## DEVELOPMENT REVIEW COMMITTEE (DRC) COMMENT REPORT

**PROJECT NAME:** Broward County Convention Center West  
Expansion

**CASE NUMBER:** R19045

**REQUEST:** Site Plan Level II Review: Broward County  
Convention Center, West Expansion of  
.177,383 Square Feet

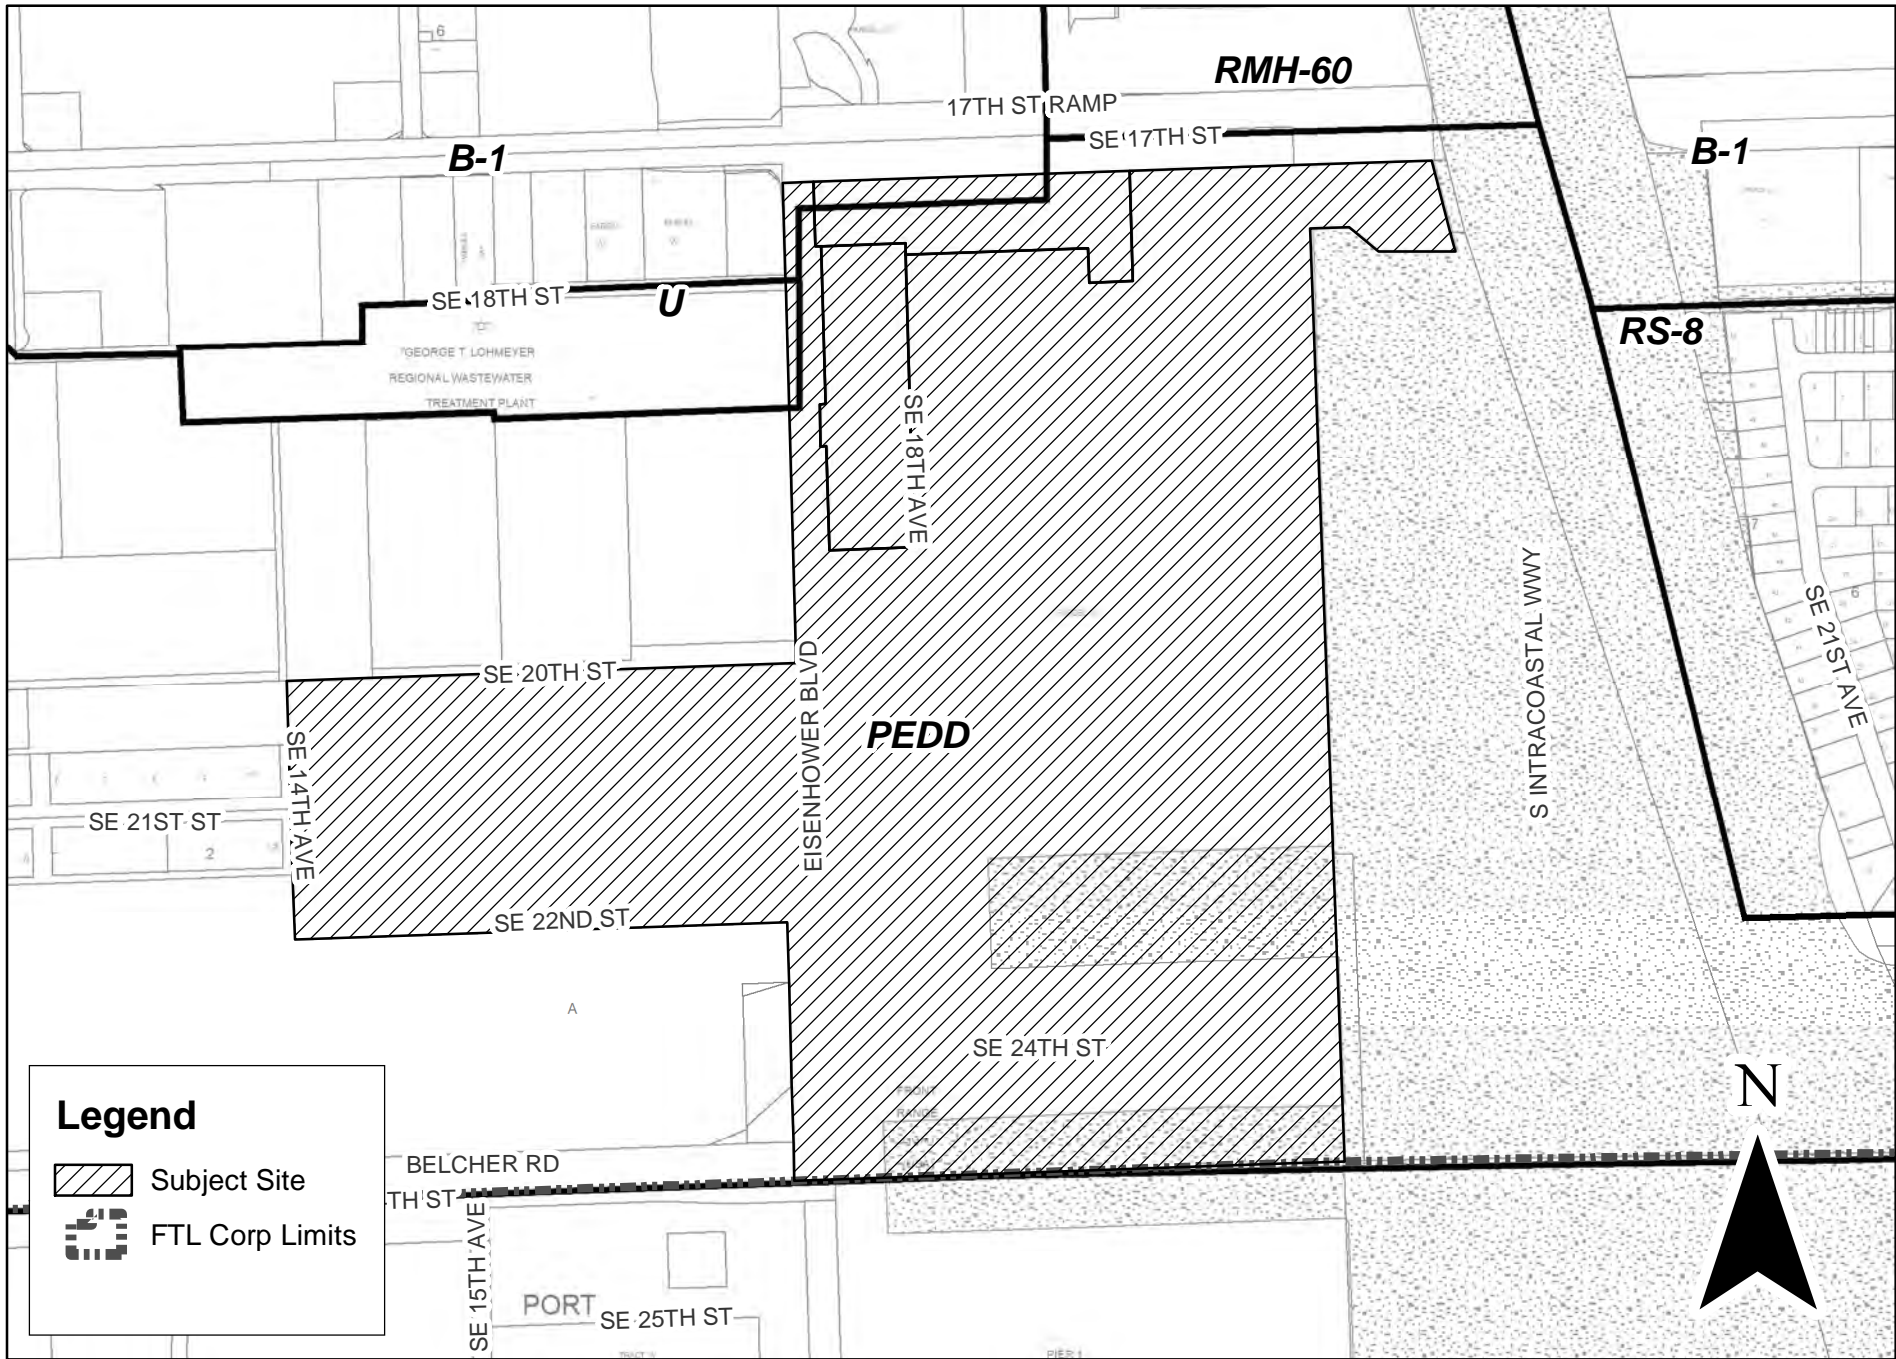
15. Provide dimensions of all sidewalks and pedestrian paths on landscape plans and site plan. Ensure that adequate shade trees are provided at sidewalk to provide ample shade to enhance pedestrian experience. In addition to understory landscape to provide an adequate buffer from loading area.
